CONSTRUCTION SUMMARY

Kingsmen (Thames) Inc. / Havelock Corners (Kingsmen)

Lot/Unit: 217 Phase/Building: 4A Model/Floor Plan: John (4201) Elev B 4 Bed - 2+1 Bath

SKETCH #1

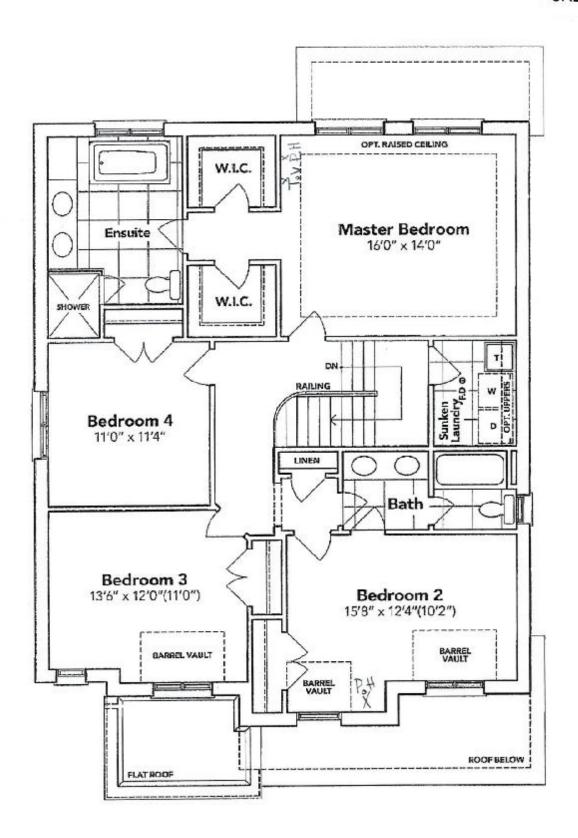
Inv. 5091	1 - To supply and install the standard T.V Rough-in, in the Great Room and Master Bedroom see sketch #1 and #2	
Line 66727	Note: iNSTALL THE T.V. ROUGH IN AT APPROX. 66" + - UP FROM THE FLOOR CENTERED + - TO THE F/P MANTLE	
23Aug21 / 24Aug21		
Inv. 5091	1 - To supply and install the standard Phone (CAT 5) rough-in, in the Great Room, Master Bedroom and Bedroom #2 see sketch #1 and #2	
Line 66728	Note: iNSTALL THE PHONE ROUGH IN AT APPROX. 66" + - UP FROM THE FLOOR CENTERED + - TO THE F/P MANTLE	
23Aug21 / 24Aug21		
Inv. 5091	1 - To SUPPLY AND INSTALL AN ADDITIONAL BASIC RECEPTACLE (NOT DEDICATED) centered +- above the F/P Mantle in the Great room, at approx. 66"+- up from the floor see sketch #1	
Line 66729	Note: THIS IS FOR A FUTURE WALL MOUNT T.V.	
23Aug21 / 24Aug21

THAMES 4A: LOT 217 RE: FRIDGE SPEC'S

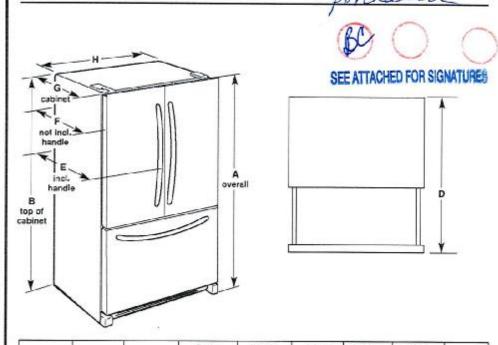
Inv. 5091	1 - See attached for fridge spec's	
Line 66739	Note:	
23Aug21 / 24Aug21
